CITY OF ALBUQUERQUE

RE: **Lot 20 Block 6, Volcano Cliffs, Unit 22, SAD 228**
8001 Camino Alto Rd. NW
Grading and Drainage Plan
Engineers Stamp Date 12/12/19 (D10D003B20)

ENGINEER'S SEAL  12/12/19 DAVID SOULE P.E. #14522	8001 CAMINO ALTO GRADING AND DRAINAGE PLAN  <i>Rio Grande Engineering</i> 1606 CENTRAL AVENUE SE SUITE 201 ALBUQUERQUE, NM 87106 (505) 872-0998	DRAWN BY: WCUJ DATE: 12-12-19 2109095-LAYOUT-12-12-19
		SHEET # — JOB # 2109095

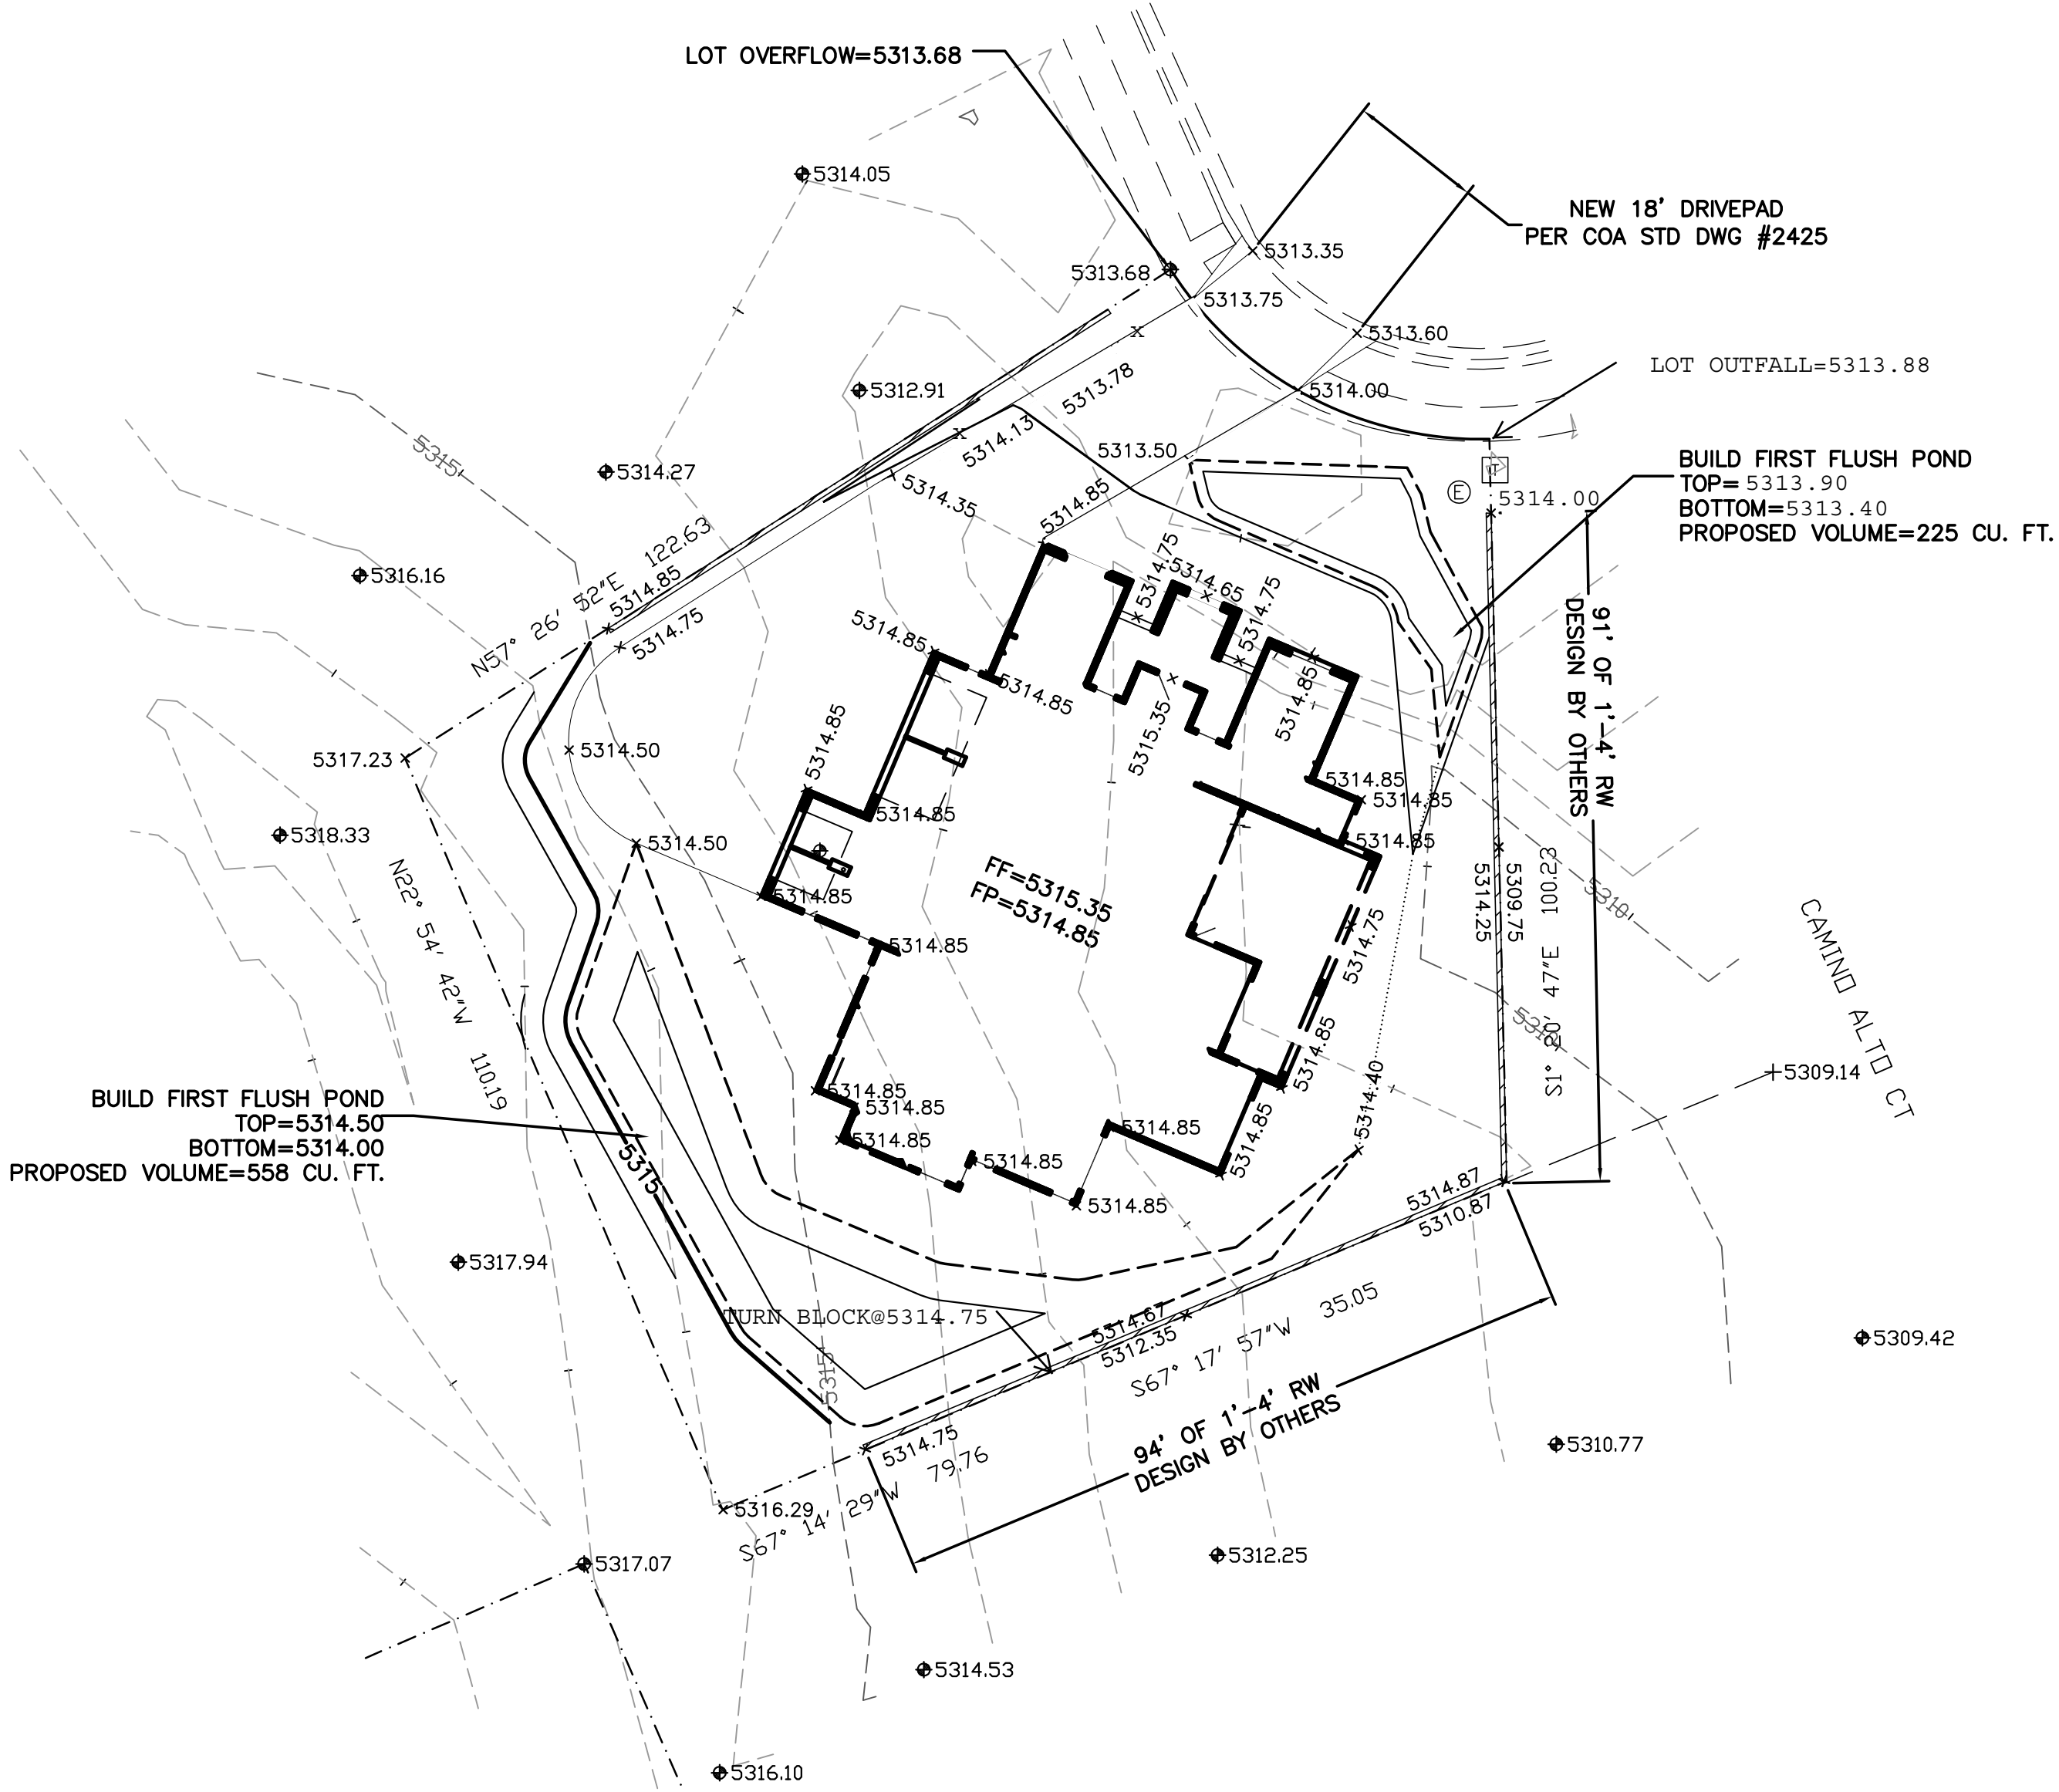
Based upon the information provided in your submittal received 12/12/19, this plan is approved for Grading Permit.

Prior to Building permit approval a Pad Certification will be required, provided by the Engineer or a registered Land Surveyor.

Advise the owner contractor not to use dirt as a ramp to climb the curb, use lumber or crusher fines for this purpose.

Reiterate to the Owner/Contractor that a separate permit for a garden/retaining wall must be obtained with the approved G&D plan and Pad Certification. Also, if a swimming pool is to be placed the grading and drainage plan will change and will need to be resubmitted.

Prior to Certificate of Occupancy release, Engineer Certification per the DPM checklist is required.
